# Work Order ID 88057

Item Name: Crosstube Assembly, Mid Fwd

DART AEROSPACE LTD HAWKESBURY, ONTARIO, CANADA	
DRAWING NO. D206-667-147	REV. A SHEET 1 OF 4
TITLE CROSSTUBE ASS'Y (206L MID FWD)	SCALE NTS

DRAWING NO. D206-667-147	TITLE CROSSTUBE ASS'Y (206L MID FWD)	REV. A	<b>DART AEROSPACE LTD ENGINEERING ORDER</b>	D.E.O. NO. D206-667-147-A-1	SHEET NO. SHEET 1 OF 1	SCALE NTS
DRAWN 90	CHECKED AJS	MFG. APPR. PB	APPROVED JMD	DE APPR. H		
DATE 11.07.15	DATE 11.07.20	DATE 11.07.21	DATE 11.07.21	DATE 11.07.21

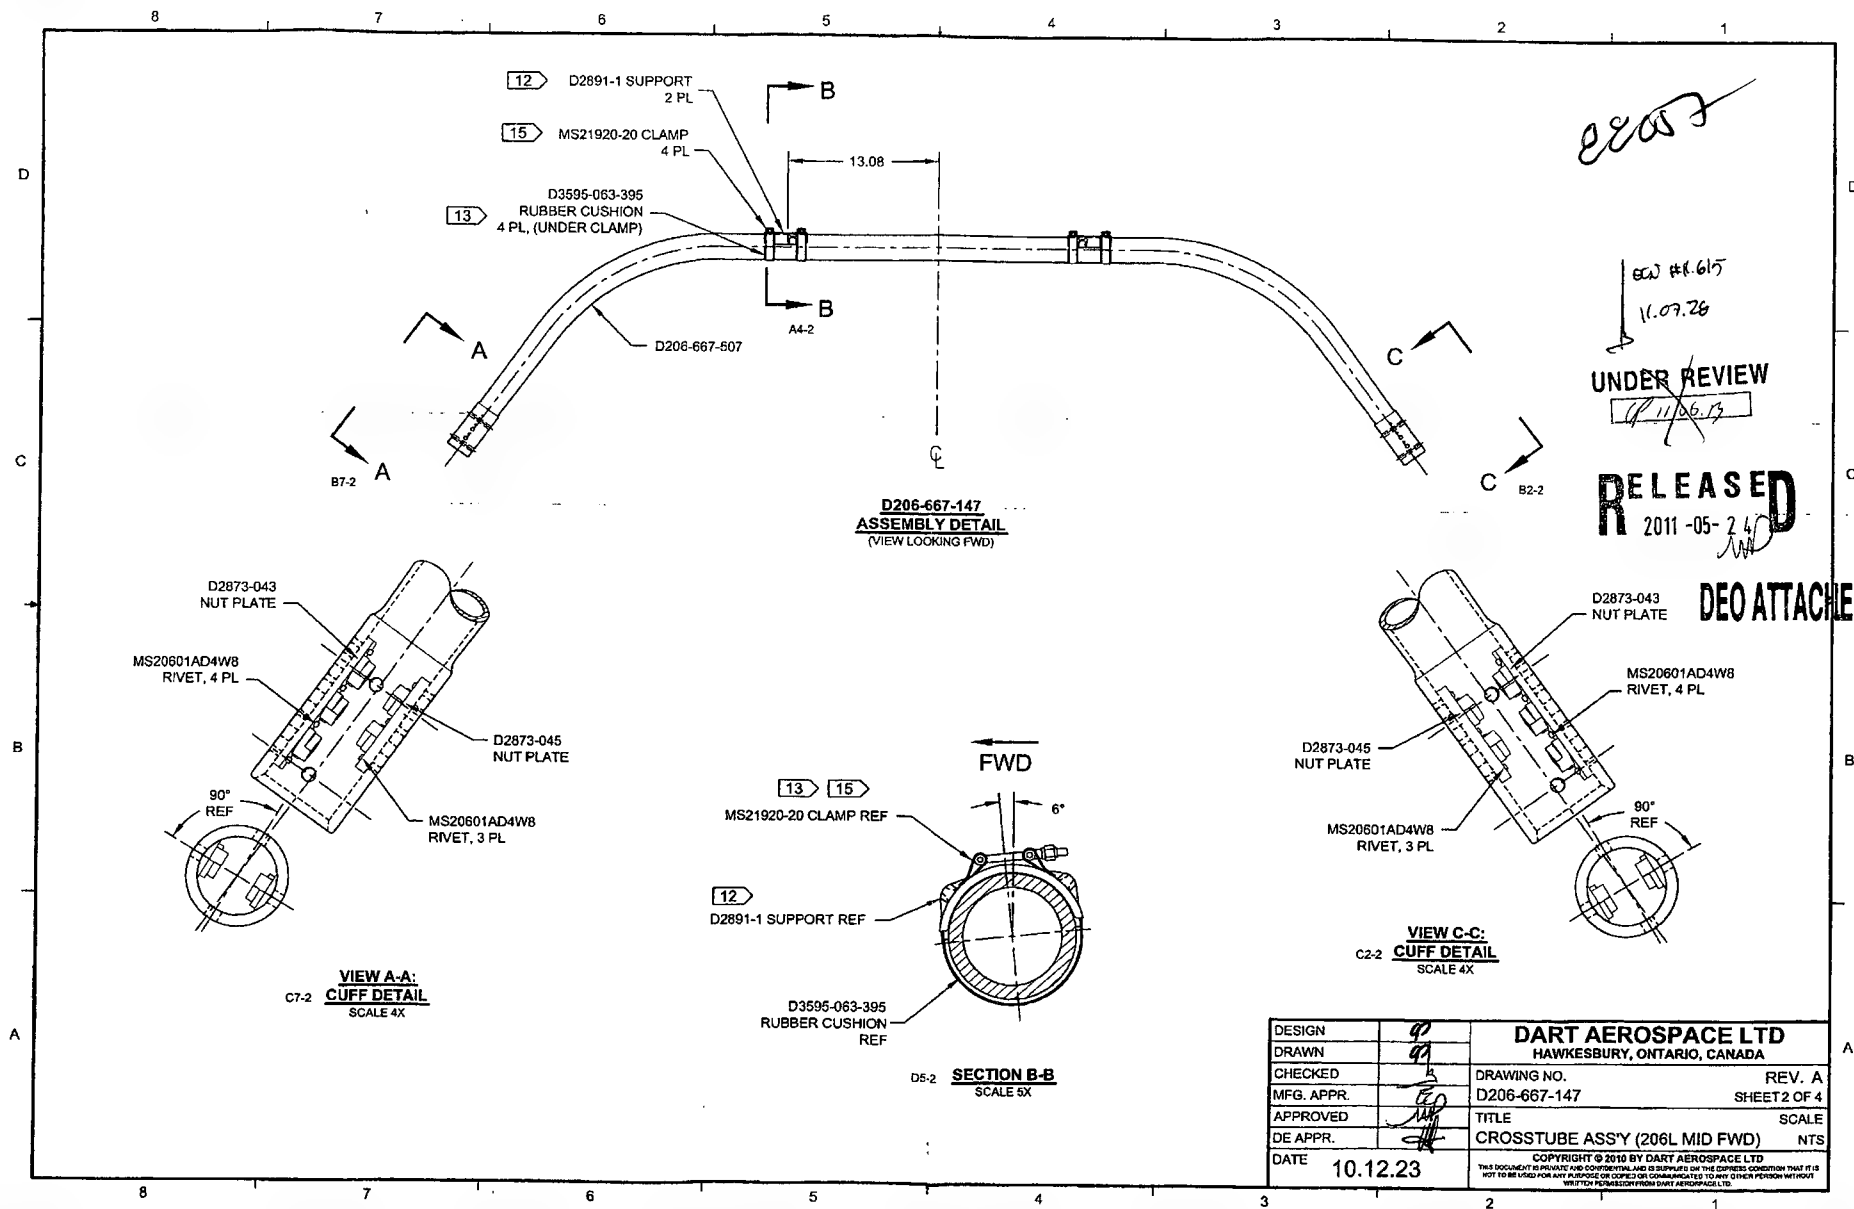
**PURPOSE:**

REPLACE MAGNOBOND WITH PROSEAL.

NOTE 12 & 15, SHEET 1 IS AMENDED AS FOLLOWS:

IS:

Item	Qty -147	Part Number	Description
9	A/R	PROSEAL 890 B-2	SEALANT, AMS-S-8802 CLASS B-2

IS:

- 12) TO INSTALL D2891-1 SUPPORT: ABRABE MATING SURFACE OF SUPPORT AND CROSSTUBE WITH 180-GRIT SANDPAPER AND REMOVE RESIDUE WITH MEK (OR EQUIVALENT). APPLY A 0.04" TO 0.07" THICK LAYER OF PROSEAL 890 CLASS B-2 (OR AMS-S-8802 CLASS B-2) SEALANT TO MATING SURFACE OF SUPPORT.
- 15) TORQUE CLAMPS 80 TO 100 IN-LB. ENSURE AT LEAST 1.5 THREADS SHOWING IN SAFETY AND THAT NUT HAS NOT BOTTOMED-OUT AFTER TORQUING. **PRIOR TO PACKAGING, RE-CHECK TORQUE ON CLAMPS AFTER PROSEAL 890 SEALANT HAS CURED FOR 72 HOURS.**
